Inspection Report / Lyons Quarry / M-1977-141

Attached is Technical Revision #5 for the Lyons Quarry M-1977-141 Reclamation Plan, Revision 2. One new attachment, Attachment I, is included as the draft Catchment Basin O&M Plan. Attachment E-1, the Kleinfelder Stability Report, is not included due to its file size. I also attached a crosswalk spreadsheet for the comments discussed in Adequacy Review #2 and where the updates were made in the corresponding documents. We hope this revision satisfies the Division's concerns but please review and let us know if you have any follow up questions.

**TR5 DRMS Adequacy Review #2 Crosswalk and Revisions 210603pdf.pdf**

Sheet 01C-02: Civil Final Grading Plan

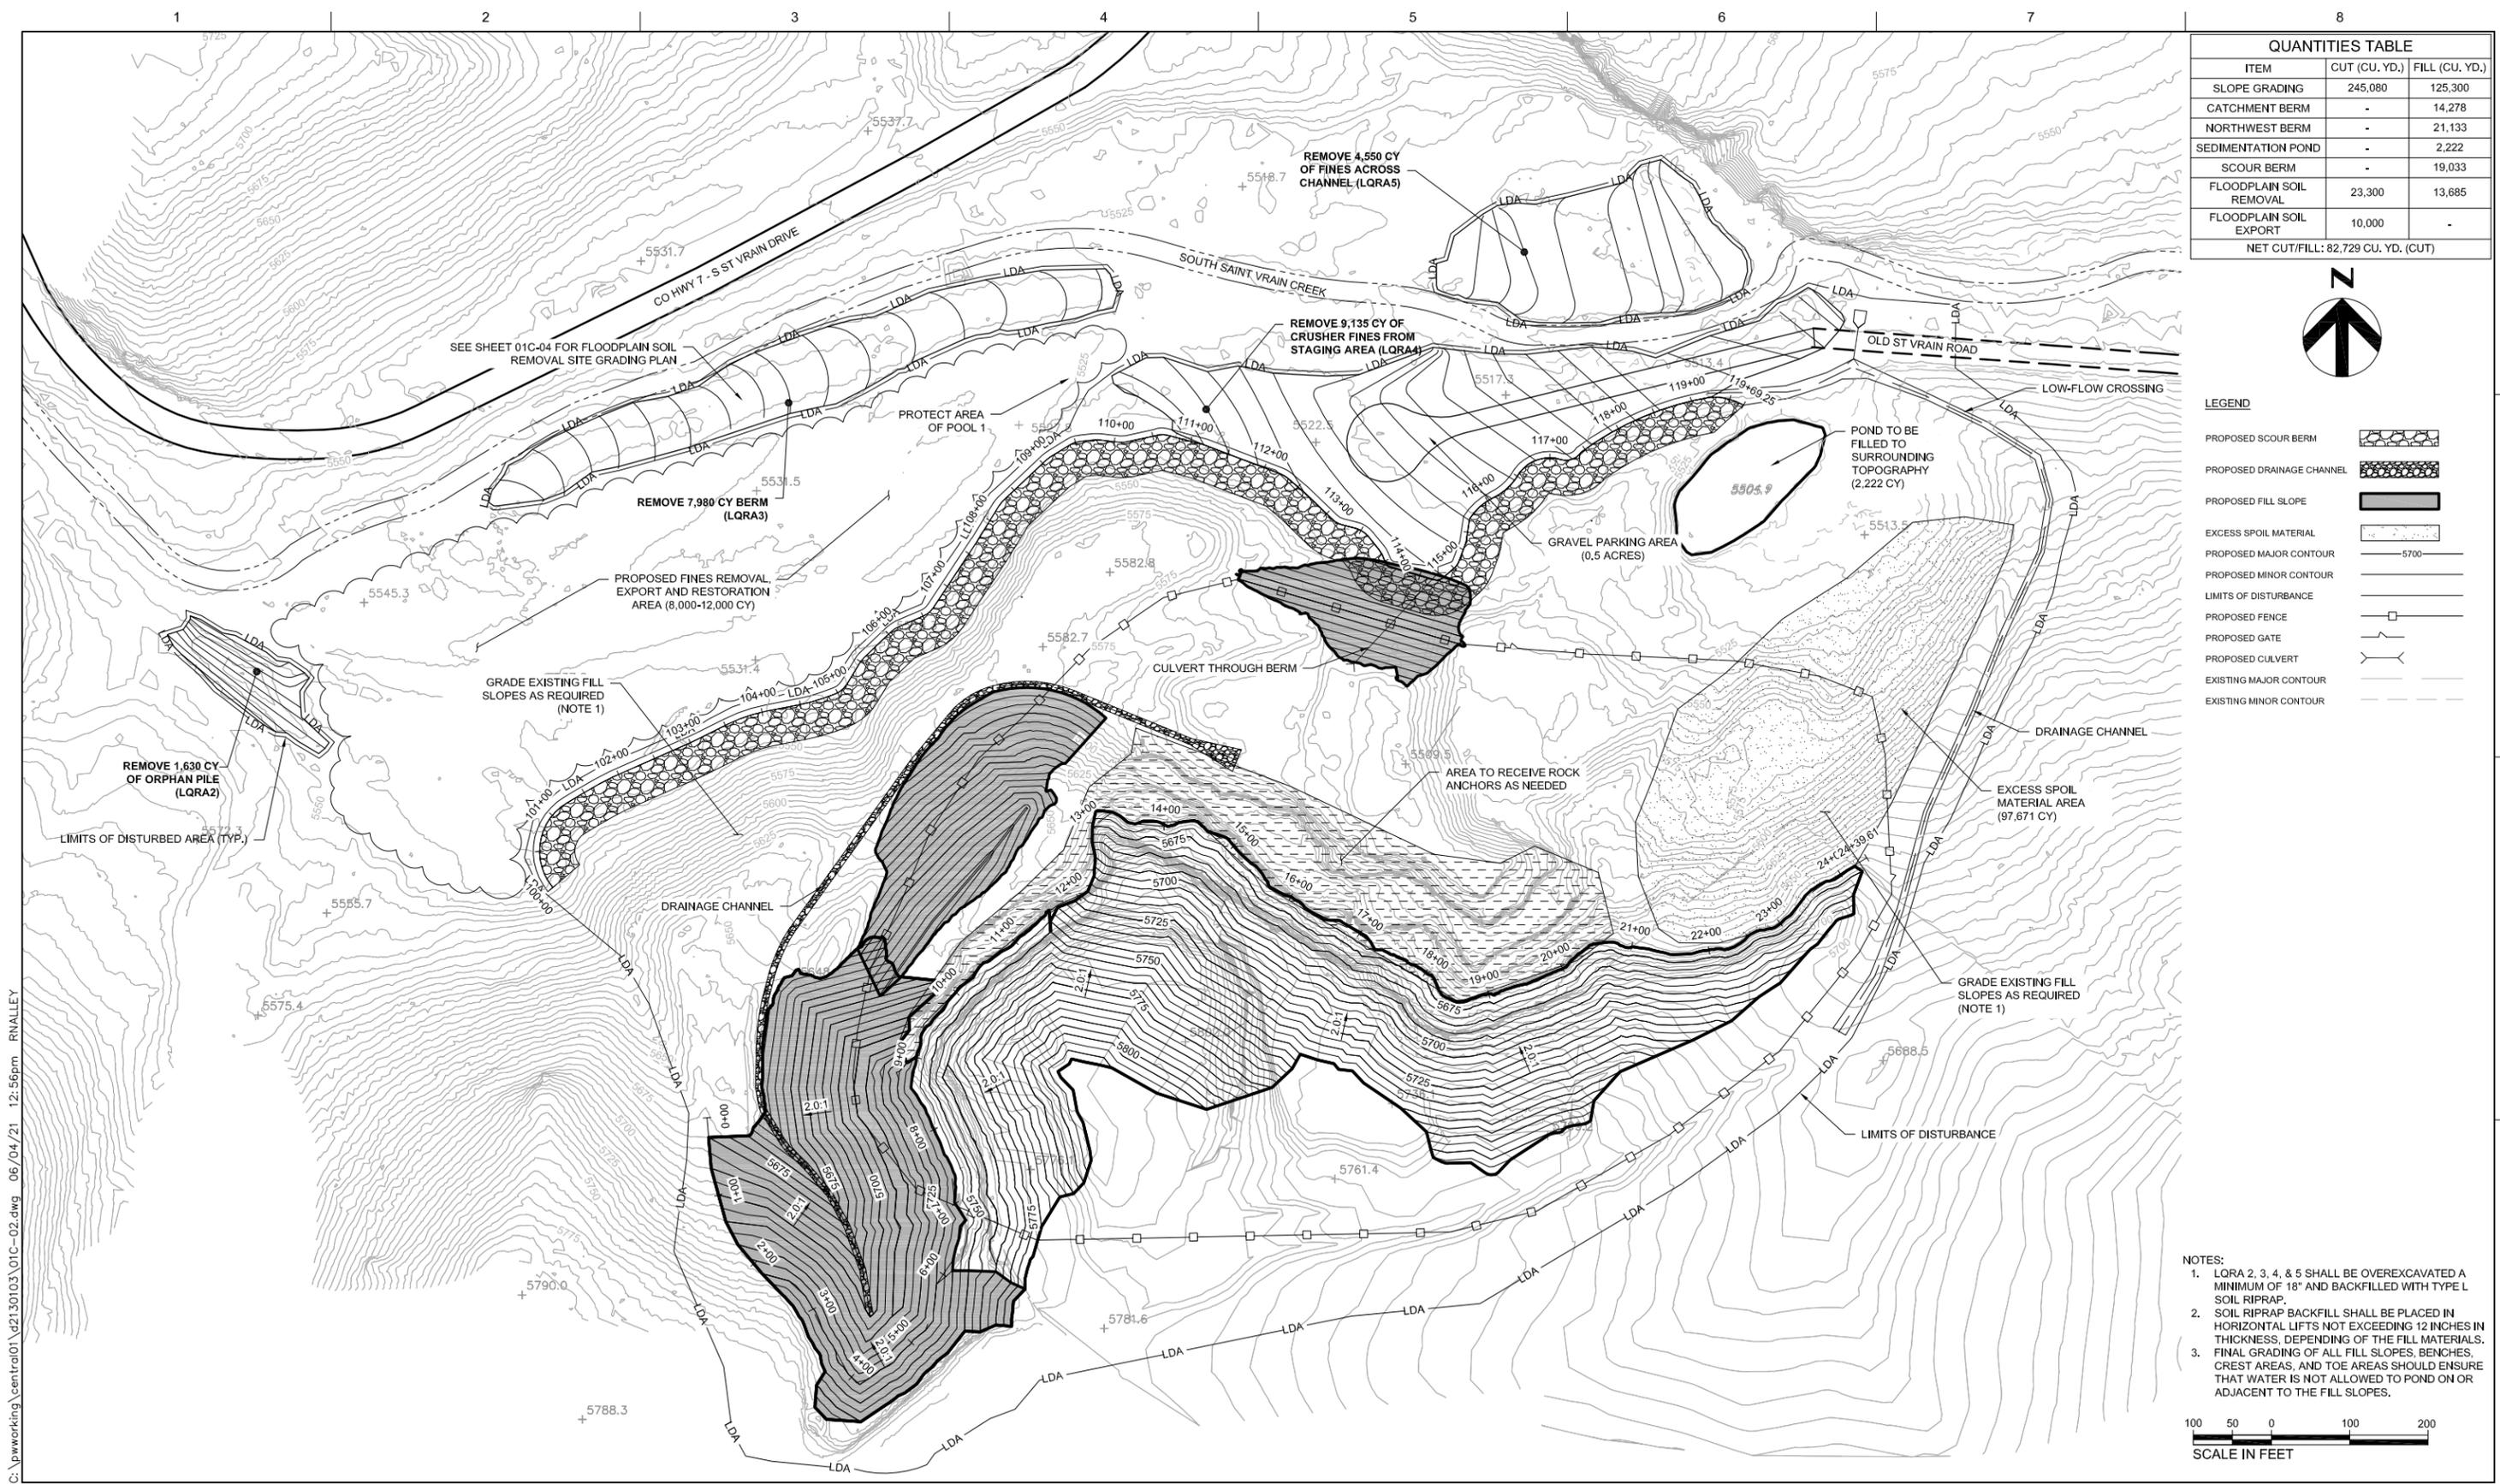
| Item # | DRMS Comment | Aggregate Response | Reference Section |
|--------|---|---|---|
| 2c | Areas that will be reinforced should be shown on the grading plan and reclamation plans. | A polygon has been added to the grading plan showing the proposed highwall areas that could be reinforced. | 01C-02 |

| 7 | Quarry 2 Swale: The Civil Final Grading Plan, Sheet 01C-02 shows 2H:1V slopes above the swale in the Quarry 2 backfill (gray-shaded area). There is a riprap-lined channel depicted to receive stormwater from this swale, but it does not appear the swale in the gray-shaded area is armored. If this is backfill, rather than competent rock, it will scour and eventually oversteepen the adjacent 2H:1V slopes. Please describe how this swale will be protected from scour. | The swale will be protected up to the 5,700 foot elevation mark with riprap at a ~8' wide section. The alignment on Sheets 01C-02 and 01C-05 have been updated to reflect this. See Sheet 01C-07 detail 4 for cross section of the drainage channel. | TR5, Attachment H, Sheet 01C-02 |
| 8 | Northwest Highwall Catchment Berm: Similar to the two previous comments there appears to be a potential erosion/scour problem with the northwest highwall catchment berm. Civil Final Grading Plan, Sheet 01C-02 shows a significant downward gradient towards the northeast along the uphill side of the northwest highwall catchment berm. Given this is to be constructed at a 1H:1V slope, stormwater flowing along the bench adjacent to the berm has the potential to scour the toe on the uphill side to the berm, thereby undermining it and causing it to fail. How is this scenario to be prevented? | This area will be revised to be graded to at least 2:1 slopes with appropriate erosion control. The excess material will be used for fill in other areas. | TR5, Attachment H, Sheet 01C-03 |
